## DEVELOPMENT REVIEW APPLICATION

For Office Use Only		
STAFF CONTACT <i>Gudelis</i>	PROJECT No(s). <i>HDR-25-01</i>	PRE-APPLICATION NO. <i>N/A</i>
NON-REFUNDABLE FEE(S) <i>0</i>	REFUNDABLE DEPOSIT(S) <i>0</i>	TOTAL <i>0</i>

<b>Site Location/Address:</b> <b>West Linn Historic City Hall</b> <b>22825 Willamette Drive</b> <b>West Linn, OR 97068</b>	Assessor's Map No.: <b>22E 31BA</b> <hr/> Tax Lot(s): <b>200</b> <hr/> Total Land Area: <b>5,570 sq. ft.</b>
--	--

**Amend the previous Class II Design Review approval (DR-22-03) to remove the awnings as required during SHPO review of the project.**

SHEET #  
**A2.1**

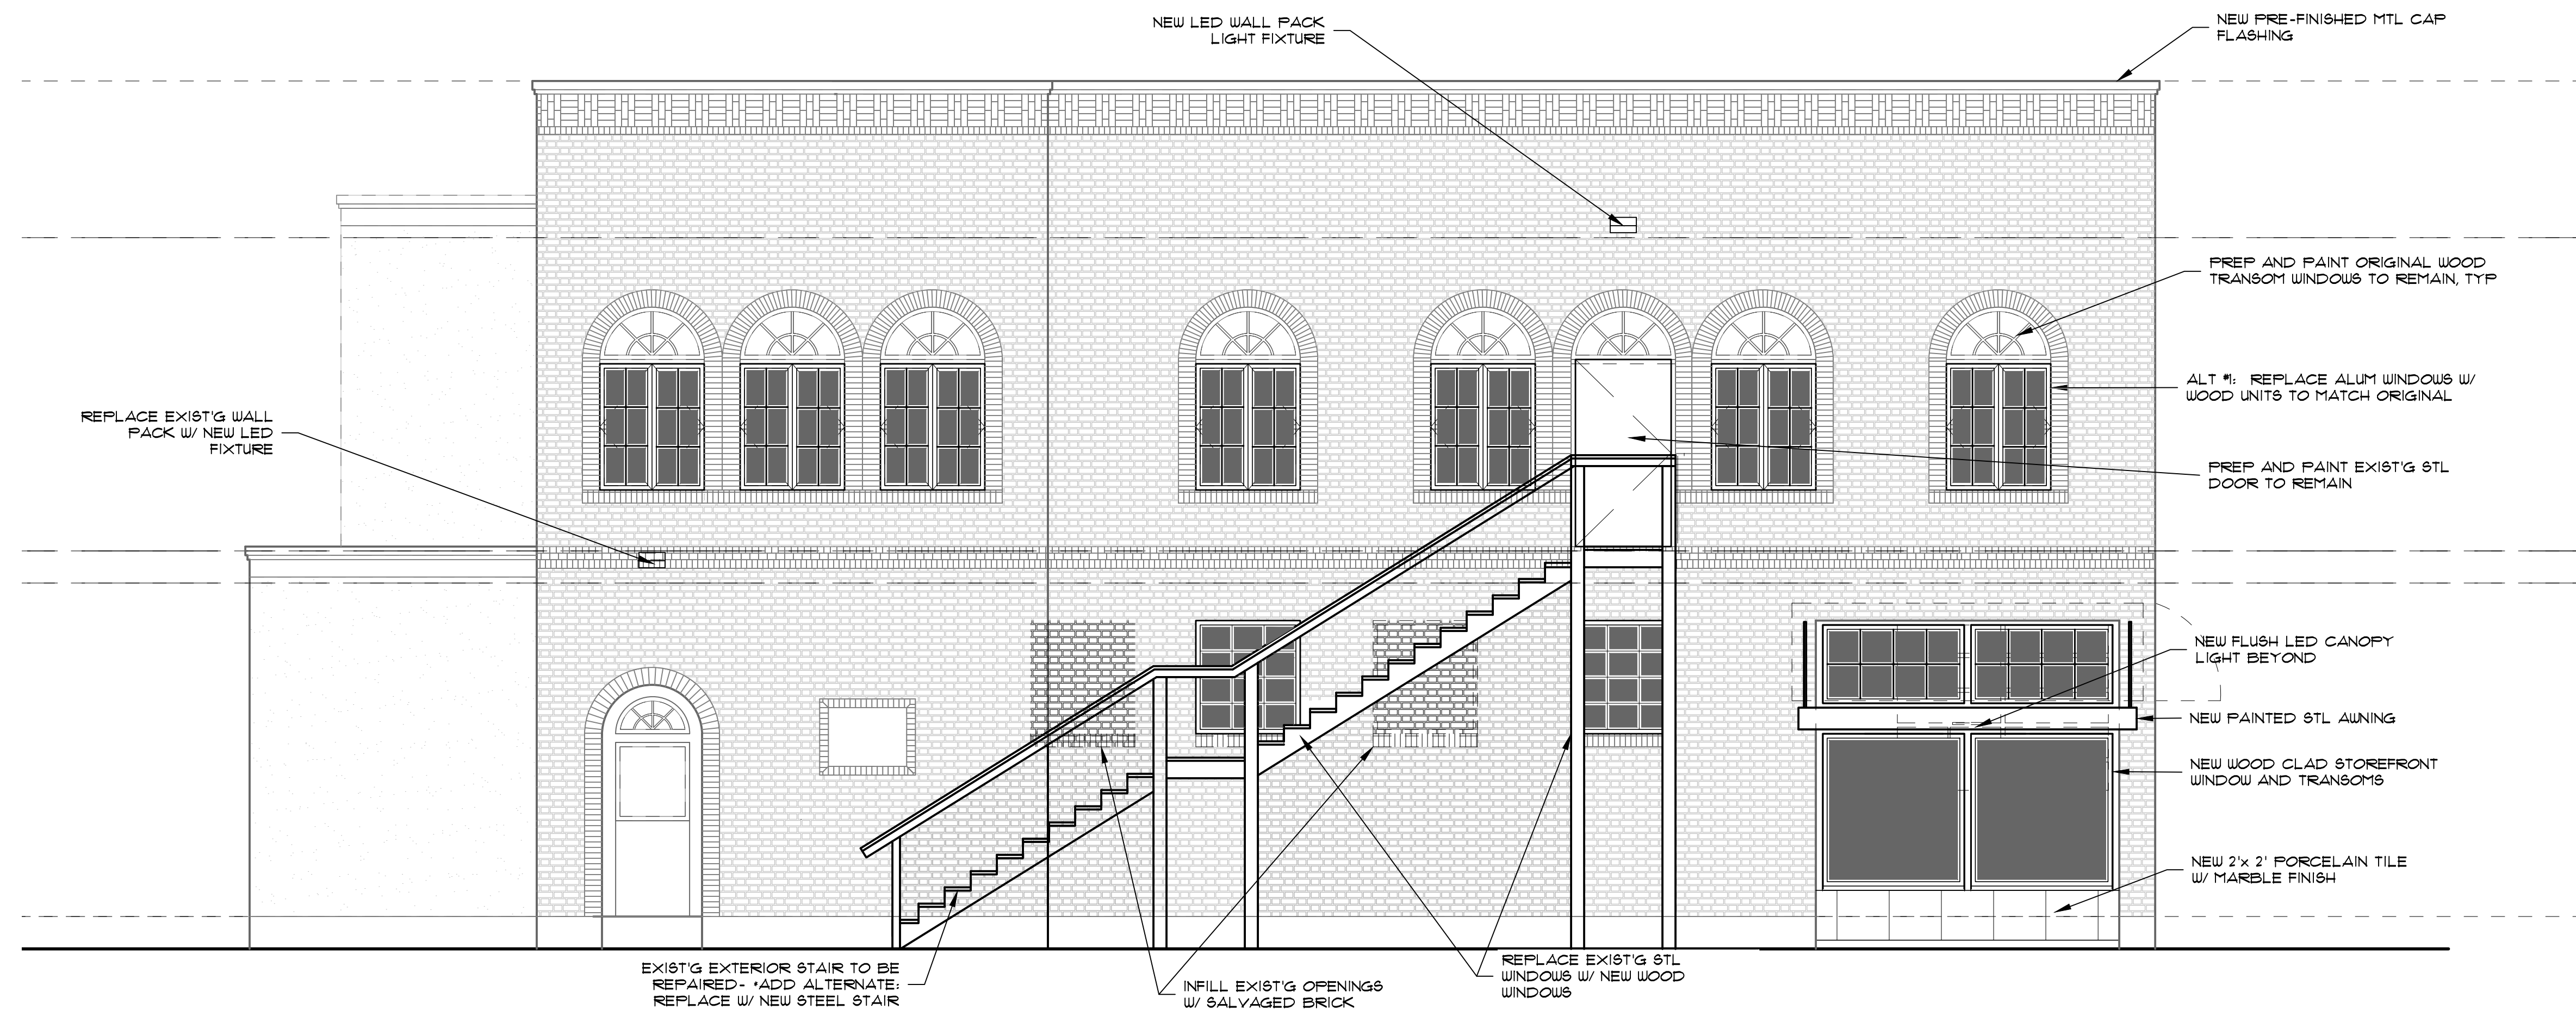
As part of the renovation process, the State Historic Preservation Office (SHPO) required a consultation to ensure the project complies with state cultural resource laws. The SHPO consultation resulted in several recommendations, including to remove the steel awnings from the front and south side of the building:

*“Regarding the awning, since historically the photos do not indicate a canopy and the submitted materials explain the decision to not install an operational awning, the proposed design of the permanent canopy over the storefronts is incompatible with the historic appearance. If a smaller version was wanted to provide shelter over an entryway, it would be acceptable to place one over the middle entryway since that section has already had significant changes.”*

- Regarding the awning, since historically the photos do not indicate a canopy and the submitted materials explain the decision to not install an operational awning, the proposed design of the permanent canopy over the storefronts is incompatible with the historic appearance. If a smaller version was wanted to provide shelter over an entryway, it would be acceptable to place one over the middle entryway since that section has already had significant changes.

*“The canopy/ awning elements were a desired addition by the Users to provide shading during the summer months and replace the current deteriorated, non-historic fabric awnings. Operable fabric awnings appear to have been installed early in the building’s history at the corner of the building but were not indicated in the original construction drawings. After much deliberation in our office, we concur with your position that the proposed elements should be omitted from the proposed Project. No additional awning element at the entry is needed since the entry doors will be recessed, similar to the original design.”*

- The canopy/ awning elements were a desired addition by the Users to provide shading during the summer months and replace the current deteriorated, non-historic fabric awnings. Operable fabric awnings appear to have been installed early in the building's history at the corner of the building, but were not indicated in the original construction drawings. After much deliberation in our office, we concur with your position that the proposed elements should be omitted from the proposed Project.

No additional awning element at the entry is needed since the entry doors will be recessed, similar to the original design.

**A2.1**

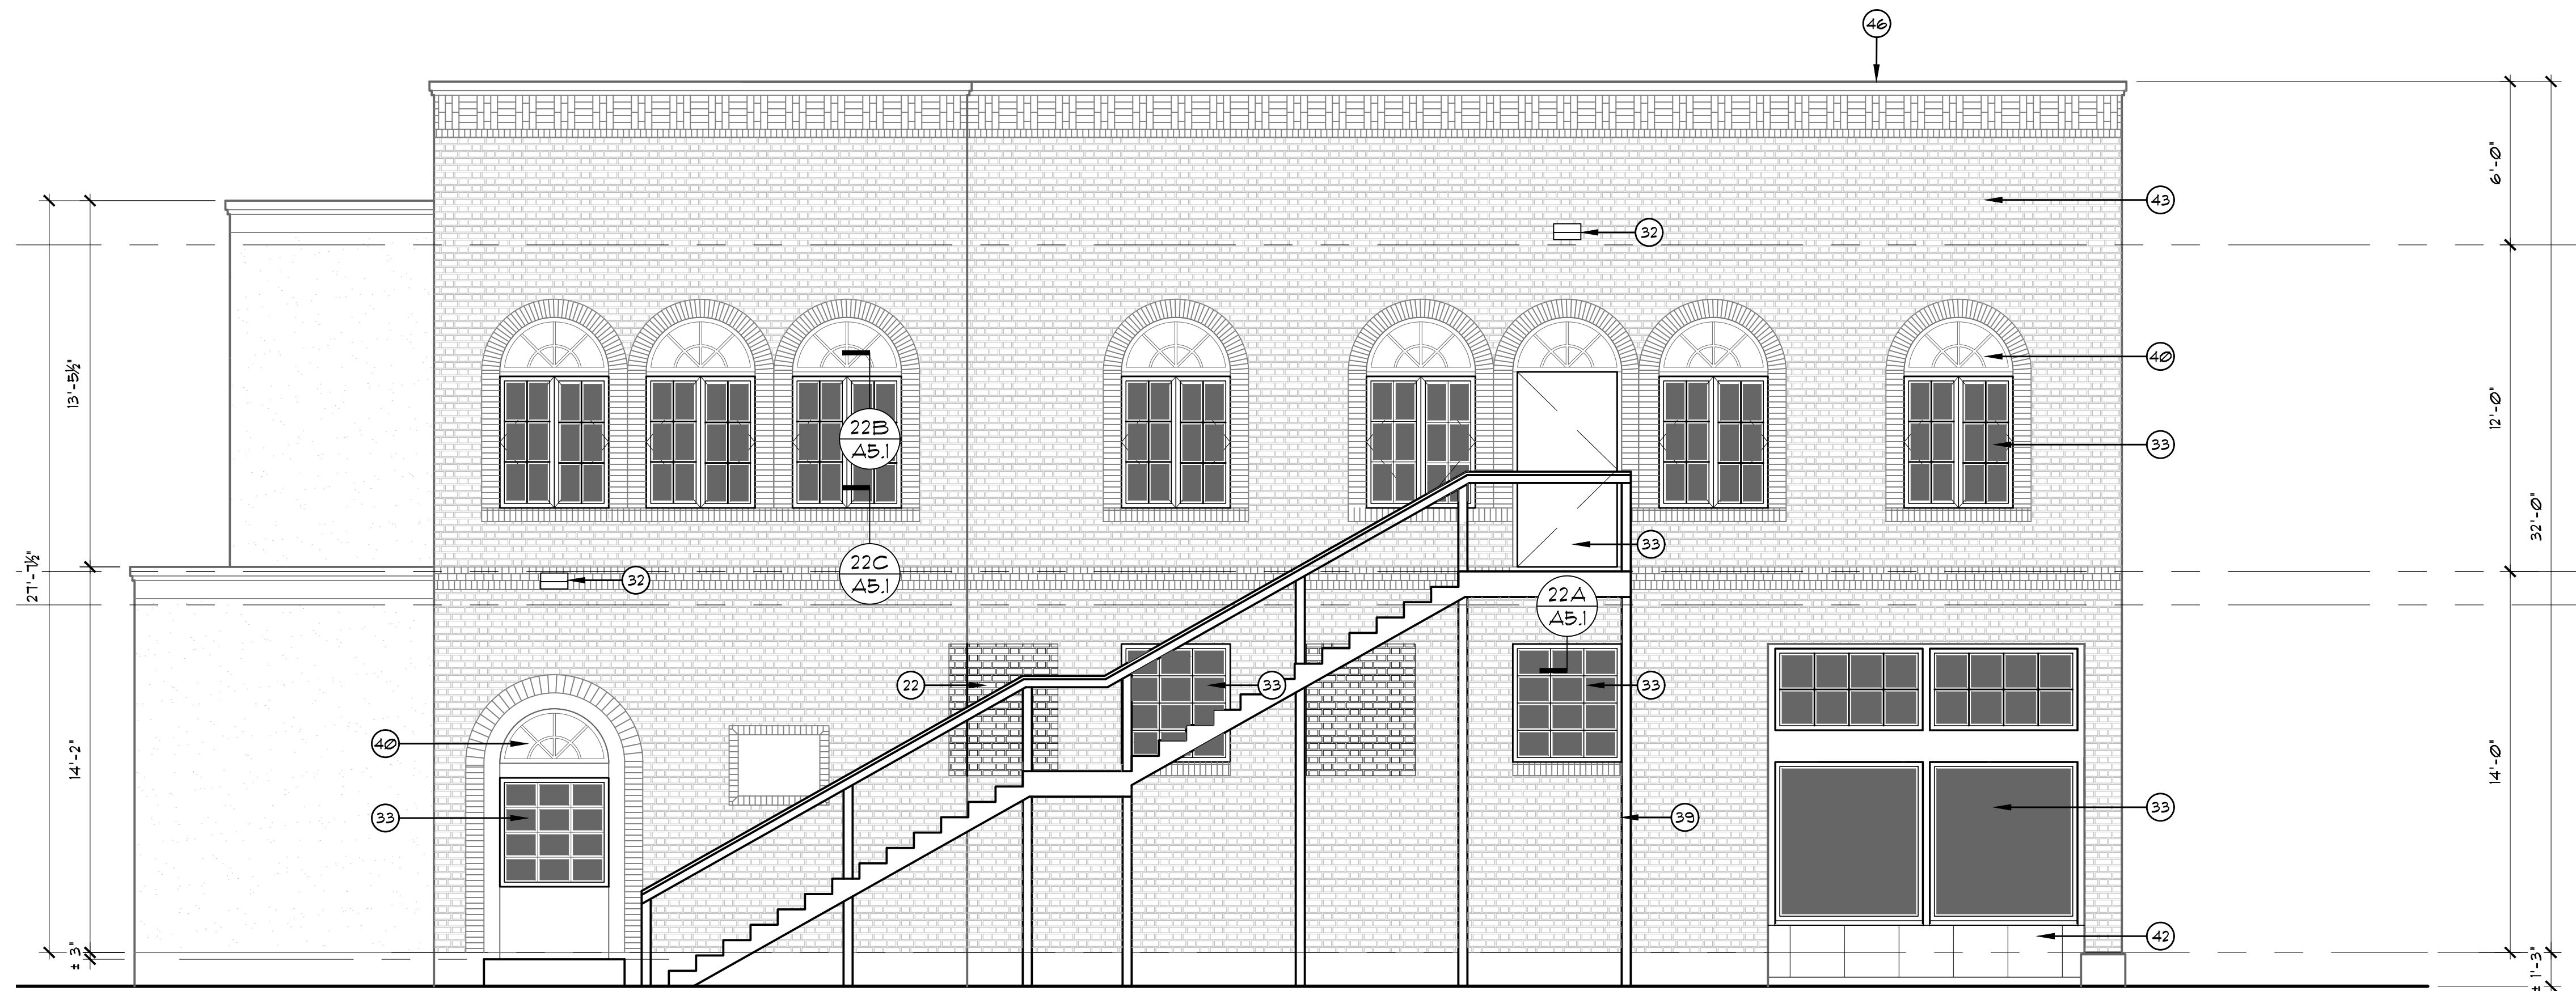
1. West Linn CDC Chapter 25 Responses
2. DR-22-03 Final Decision and Order by the Historic Review Board
3. DR-22-03 Approved Plans with steel awning
4. SHPO Letter dated February 26, 2024
5. City Response Letter to SHPO
6. SHPO Letter in response to City dated April 8, 2024
7. Revised Plans with steel awning removed
